## Architectural Review Committee Staff Report Meeting Date: April 22, 2024

**PETITION:** Enclave at Deer Crossing Product Approval

**REQUEST:** Petitioner requests approval of the Elmstead E – Deluxe Craftsman for Lot 11 of the

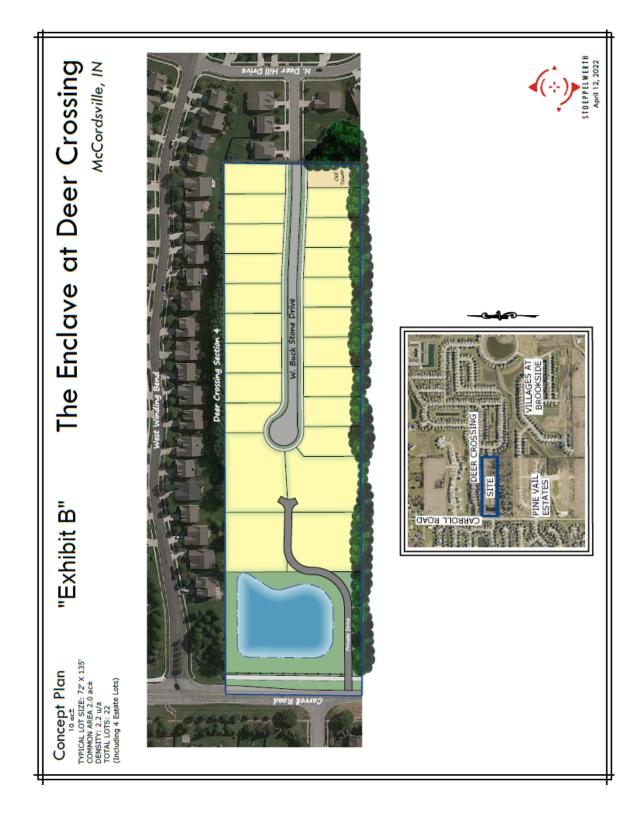
The Elmstead E – Deluxe Craftsman, as presented, is almost entirely comprised of a brick and stone exterior. Staff finds the home, generally, in compliance with the architectural standards of the PUD, with the following exceptions:

- 1. A window is needed on the right-side elevation; and
- 2. The window on the left-side elevation is required to feature a grid or shutters.

Following resolution of the two items noted above, and review of anti-monotony, staff will recommend approval of this petition.
